### **Municipality of Anchorage**

Case No. 2020-0043, Spenard Corridor Plan

#### Planning and Zoning Commission Review and Approval

#### **ISSUE-RESPONSE SUMMARY**

# Planning Staff Recommended Changes to Public Hearing Draft Figures 3.7 and 4.5:

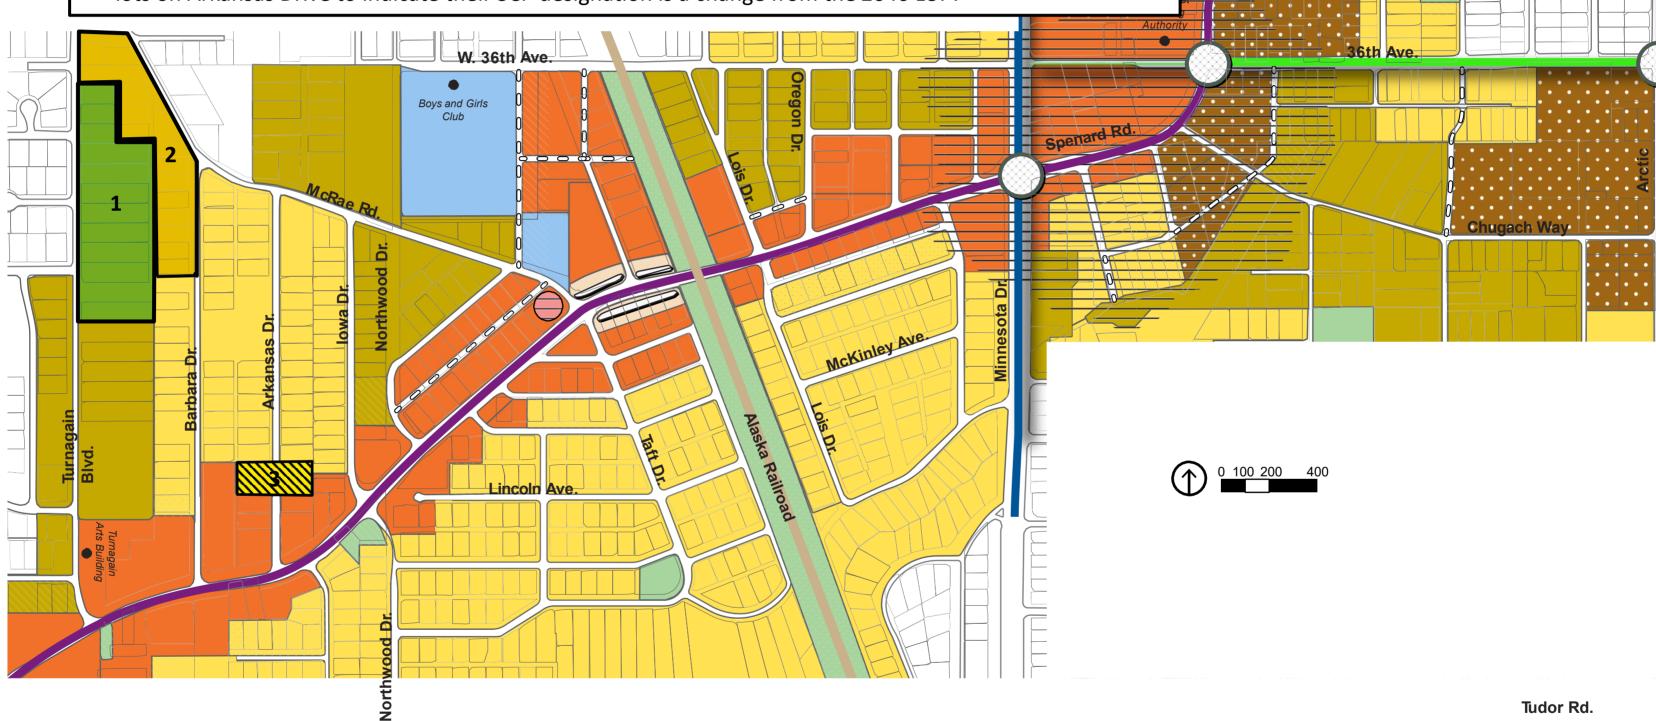
- 8. The Department recommends two site-specific land use designation adjustments to Chapter 3, Figure 3.7, and Chapter 4, Future Land Use Figure 4.5, and one other land use designation change to Chapter 4, Figure 4.5 only. These are depicted and described in Attachment 4. These three map designation changes bring these figures into consistency with the 2040 LUP, and in one case indicates a Plan designation change from the 2040 LUP.
- 9. In order to avoid confusion about locating future neighborhood serving commercial uses as depicted on the Chapter 4, Future Land Use Figures, staff recommends modifying the title and text for the second paragraph on page 79.

- 1. Correct land use designation on Kiwanis Fish Creek Park from "Compact Mixed Residential-Medium" to "Park, Natural Area or Open Space," to reflect the 2040 LUP land use designation of this dedicated parkland.
- 2. Correct the land use designation for the residential properties abutting Kiwanis Fish Creek Park to its east and north from Compact Mixed Residential-Medium to "Compact Mixed Residential-Low," to better reflect the existing housing, R-1 and R-2M zoning, and the 2040 LUP. This corrects an inadvertent deviation from these to a higher-density residential designation than intended.
- 3. (Figure 4.5 only) Add diagonal line pattern to the southernmost four residentially-designated lots on Arkansas Drive to indicate their SCP designation is a change from the 2040 LUP.
